14 CFR Part 39

[Docket No. 2000-CE-44-AD; Amendment 39-12920; AD 2002-21-13]

Airworthiness Directives; Raytheon Aircraft Company Beech Models 35, 35R, A35, and B35 Airplanes

ACTION: Final rule.

Figure 1

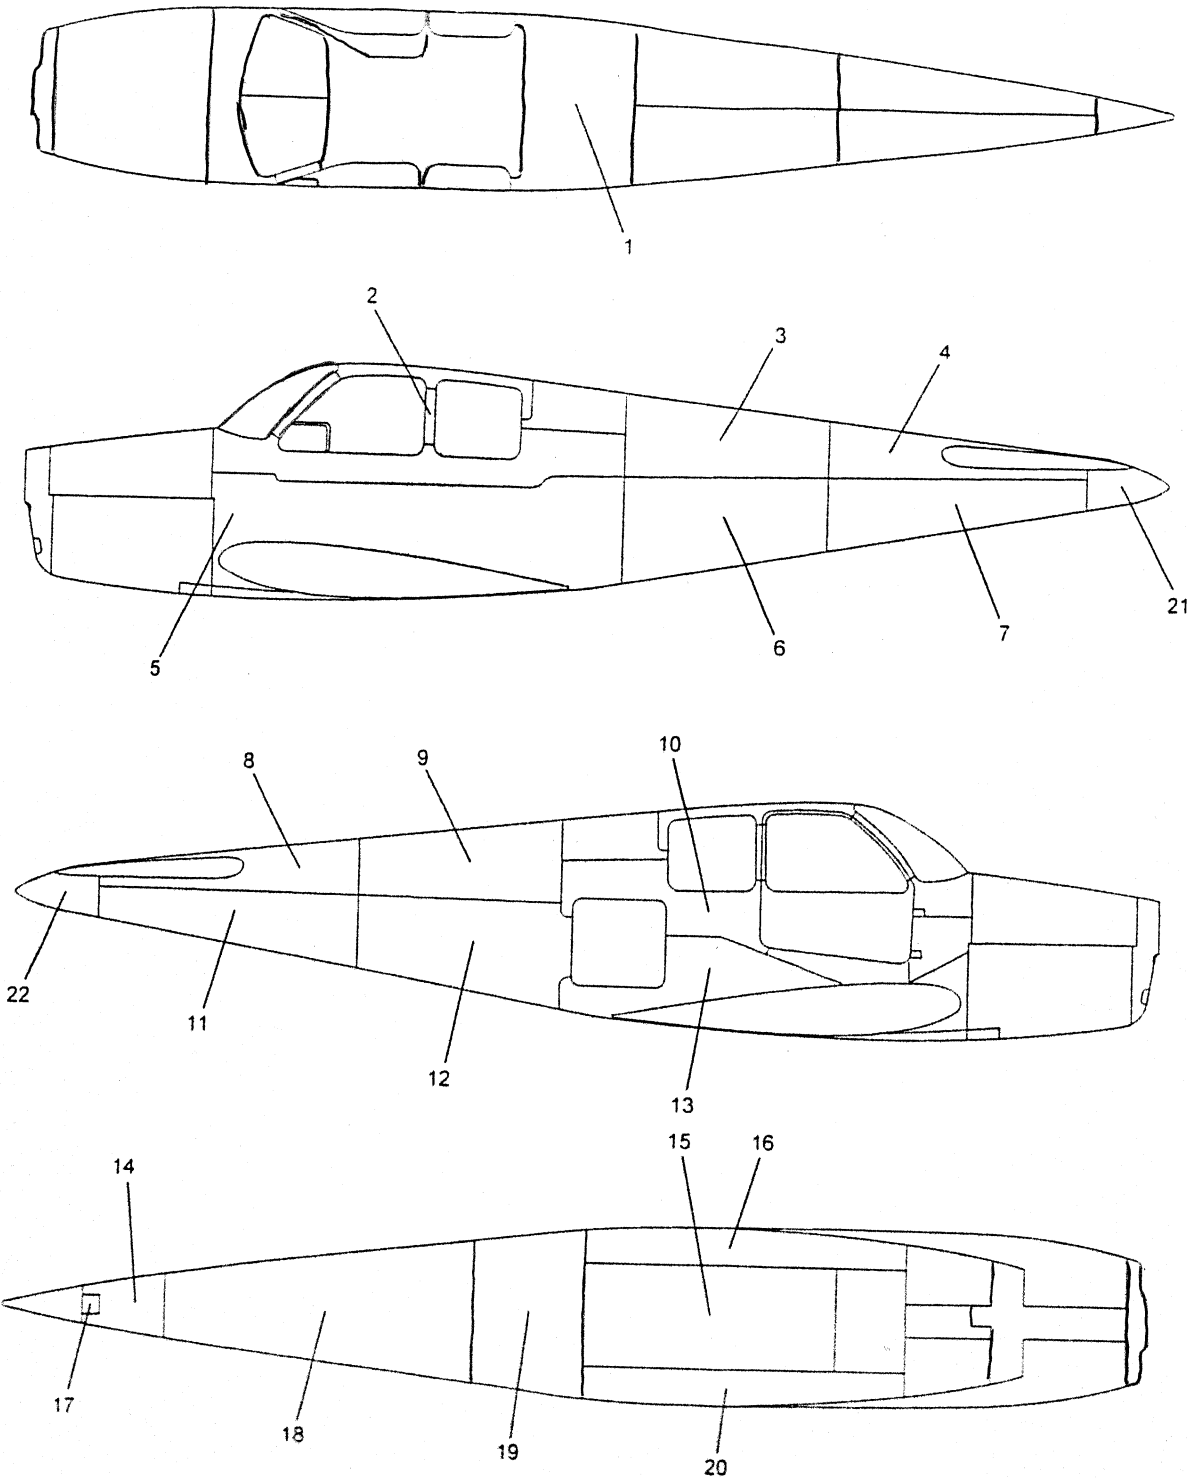
Comment Issue No. 2: Allow Equipment Options for Skin Thickness and Acknowledge Differences in Skin Thickness

Several commenters present the same concern with the equipment used to measure skin thickness as that concern with the propeller balancing. That

concern is specifying only one piece of equipment. These same commenters also state that there are differences in skin thickness, e.g., 0.016 inch instead of 0.018 inch.

We concur that specifying only one piece of equipment for the skin thickness measurement is too restrictive.

We are changing the final rule AD action to state that you must accomplish this measurement in accordance with a digital ultrasonic skin tester or equivalent skin tester or by direct methods that utilize calipers and micrometers.

We also concur that there are differences in skin thickness. We are adding to the final rule AD action reference to the different skin thicknesses that are specific to each airplane serial number and the location (fuselage stations) of each affected skin part number.

(5) Visually inspect the empennage, aft fuselage, and ruddervator control system for damage: (i) Part of this is an inspection of the aft fuselage skin for wrinkles or cracks. Specific skin thicknesses are presented in Figures 1 and 2 of this AD. The skin thickness measurement is not repetitive. (ii) The inspection and setting of the travels on the elevator and elevator trim tabs are not repetitive. (iii) Repair or replace any damaged parts and set the elevator controls, rudder and tab system controls, cable tensions, and rigging.	Inspect within the next 100 hours TIS after the last inspection required by AD 94-20-04 or within the next 25 hours TIS after December 10, 2002 (the effective date of this AD), whichever occurs later, and thereafter at intervals not to exceed 100 hours TIS, except for the skin thickness measurement and the inspection and setting of the travels on the elevator and elevator trim tabs, which are one-time actions. Accomplish any repairs, replacements, and adjustments prior to further flight after the applicable inspection.	Accomplish the inspection and repairs or replacements in accordance with the procedures in paragraphs (5)(a) through (5)(f) of the ACCOMPLISHMENT INSTRUCTIONS section of Raytheon Service Bulletin No. SB 27-3358, Issued: February, 2000, and use a digital ultrasonic skin tester or equivalent skin tester or direct methods that utilize calipers and micrometers. Specific skin thicknesses are contained in Figures 1 and 2 of this AD.
